Discovery Point, Wolli Creek Concept Plan

Building 1B Envelope Parameters

Drawing no.
DA3-002

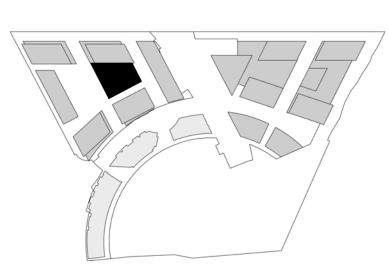
Amendments since Revision A Envelope increased to include podium of building 4; Envelope reduced at East to increase building separation
